**Subject:** Request for Equivalent Feed Determination, DISA Technologies, Inc., License No. SUA-1605, Docket Number 40-38417

On March 19, 2026, DISA Technologies, Inc. (“DISA”) and staff from the U.S. Nuclear Regulatory Commission (NRC) met to discuss a request by DISA and the Navajo Nation (see Attachment 1) to determine that the fines concentrates generated from the use of High-Pressure Slurry Ablation (HPSA) for treating uranium mine waste are equivalent feed. During our meeting, the staff provided DISA with a list of questions that it adopted from work performed by the Utah Division of Waste Management and Radiation Control (DWMRC) during a previous equivalent feed determination. This letter provides DISA’s responses to those questions, which are organized by presenting the staff’s question followed by DISA’s response.

ATTACHMENT 2

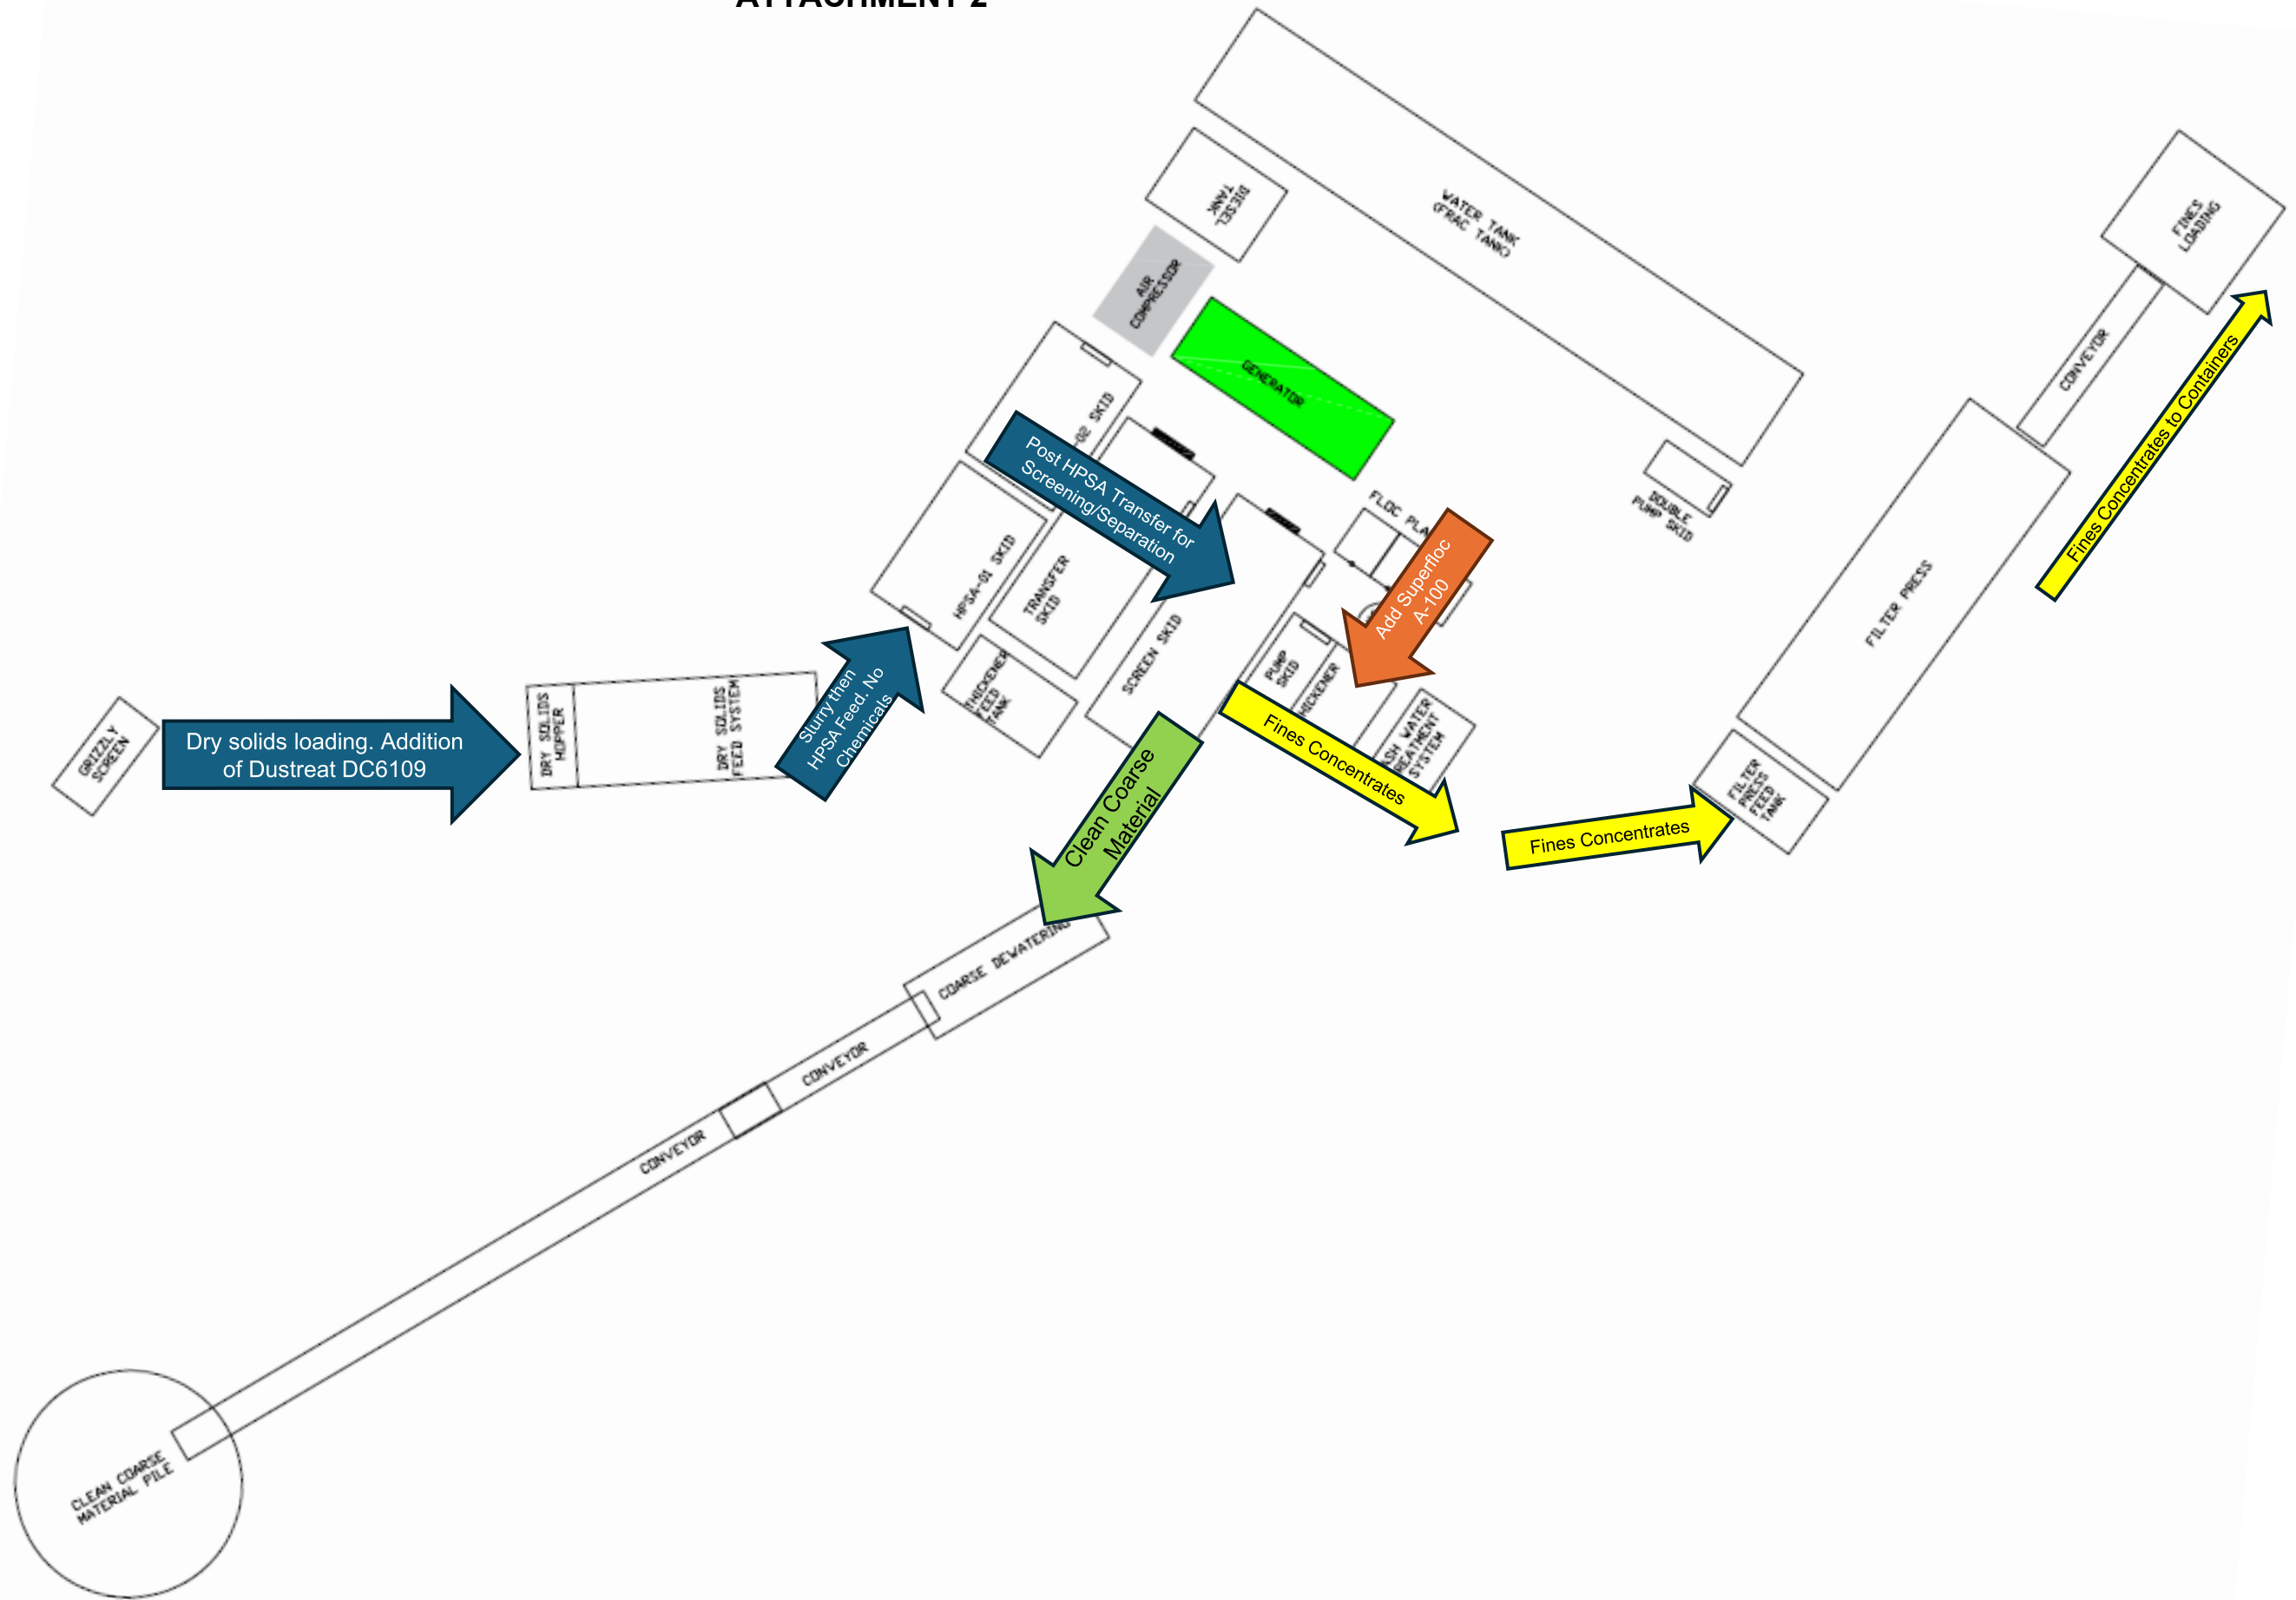
1. Provide a schematic of the HPSA process including all physical and chemical steps, demonstrating that the fines concentrates resulting from the process are not chemically changed or altered in any way from the AUM waste in its natural or native state.

**Response:** Attachment 2 is a flow sheet showing the HPSA C-10, 10-tons-per-hour unit. The HPSA process does not use any chemicals to separate the uranium from the waste rock matrix. It is a physical process of crushing and grinding (with a dust suppression agent described in No. 2), creating a slurry (using water), and then shooting the slurry into our collision cell through diametrically opposed nozzles. The high-pressure streams cause particle collisions that liberate minerals along grain boundaries. These collisions provide the separation necessary to classify the fines concentrates via screening. Downstream of the screens, the coarse material is dewatered and used to reclaim the site. The fines are thickened using a flocculant (described in No. 2), dewatered, then placed into containers and transported offsite. As described below, the dust suppressant

and flocculant are innocuous, will not react with the waste rock or fines concentrates, and will not alter the chemical or mineralogical composition.
